TOWN OF FLOWER MOUND, TEXAS

ORDINANCE NO. 31-19

AN ORDINANCE OF THE TOWN OF FLOWER MOUND, TEXAS, AMENDING CHAPTER 14, "BUILDINGS AND BUILDING REGULATIONS," ARTICLE XIV, OF THE CODE OF ORDINANCES OF THE TOWN OF FLOWER MOUND, TO PROVIDE FOR ADOPTION OF THE *INTERNATIONAL RESIDENTIAL CODE*, 2018 EDITION, AND LOCAL AMENDMENTS THERETO; PROVIDING THAT THE BOARD OF ADJUSTMENT SHALL BE THE BOARD OF APPEALS FOR PURPOSES SET OUT HEREIN; REPEALING ALL CONFLICTING ORDINANCES; PROVIDING A SEVERABILITY CLAUSE; PROVIDING A PENALTY; PROVIDING FOR PUBLICATION; AND PROVIDING AN EFFECTIVE DATE.

FIGURE R602.6.1
Top Plate Framing to Accommodate Piping

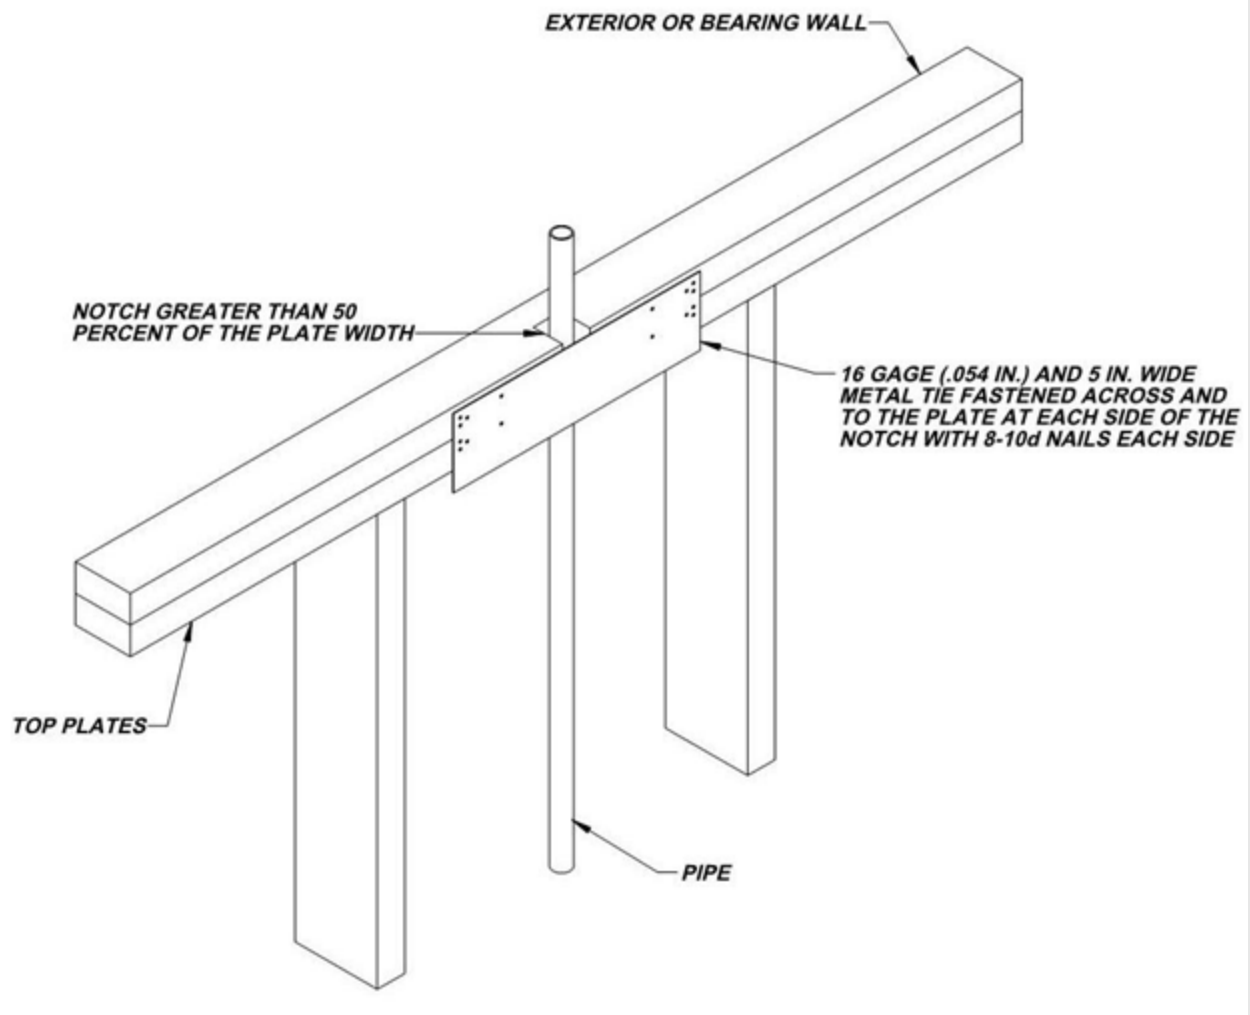
- (ee) Section R602.6.1 of the *International Residential Code*, 2018 edition, is hereby amended, the Exception is deleted in its entirety, and Figure R602.6.1 is replaced with a new Figure R602.6.1, entitled "Top Plate Framing to Accommodate Piping" to read as follows:

Section R602.6.1 Drilling and notching of top plate. When piping or ductwork is placed in or partly in an exterior wall or interior load-bearing wall, necessitating cutting, drilling, or notching of the top plate by more than 50 percent of its width, a galvanized metal tie not less than 0.054 inch thick (1.37 mm) (16 Ga) and 5 inches (127 mm) wide shall be fastened across and to the plate at each side of the opening with not less than eight 10d (0.148 inch diameter) having a minimum length of 1 ½ inches (38 mm) at each side of the notch to the first nail hole or equivalent. Fasteners will be offset to prevent splitting of the top plate material. The metal tie must extend a minimum of 6 inches past the opening. See figure R602.6.1.
